1. General				
(a) Service Bulletin No.:	22			
(b) Revision / Date	e 0/May 2014			
	Replacement of Pressure Gauge Fittings			
(c) Description:	Replacement of brass pressure gauge feed tube and compression fittings with stainless steel alternative			
(d) Applicability:	EASA.BA.012 & EASA.BA.013 Burner Assembly Numbers: CB2008, CB2031, CB2059, CB2065, CB2075, CB2081, CB2085, CB2086, CB2089, CB2095, CB2096, CB2097, CB2101, CB2103, CB2104, CB2111, CB2113, CB2119, CB2145, CB2153, CB2195, CB2215, CB2222, CB2239, CB2240, CB2242, CB2243, CB2244, CB2255, CB2256, CB2289, CB2298, CB2299, CB2301, CB2305, CB2342, CB2351, CB2395, CB2446, CB2459, CB2460, CB2461, CB2465, CB2466, CB2467, CB2469, CB2478, CB2479, CB2494. Note: Applicable to all variants of the above assembly numbers (e.g1, -2)			
(e) Effectivity:	All CN where the above assemblies are fitted.

FIG1: Brass Fittings

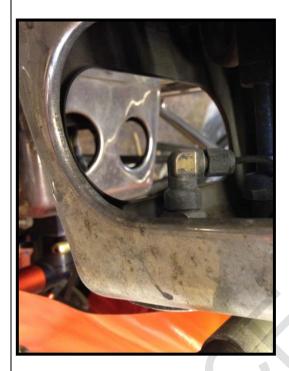
Isolated incidents have been reported where the pressure gauge inlet fitting has developed a hair line crack allowing a small leakage of fuel which can cause a small localised fire in the burner can. The incidents have only occurred where the pressure gauge inlet fitting is manufactured from brass (burners manufactured pre-1999).

Inspect each burner unit to determine whether the pressure gauge fittings are brass or stainless steel (see figure 1 and 2).

5.2 Replacement of Brass Fittings

- **5.2.1** Undo compression joints at both ends of the pressure gauge feed tube, remove the tube and discard.
- **5.2.2** Undo and remove the brass fittings and discard; ensure manifold block is free from debris/old tape.
- **5.2.3** Fit the straight st. steel fitting to manifold block using PTFE tape/paste or Loctite 572.

5.2.4	Fit st. steel elbow fitting to pressure gauge using PTFE tape/paste taking care to position fitting to accept tube.					
5.2.5	Fit new st. steel tube and tighten compression fittings.
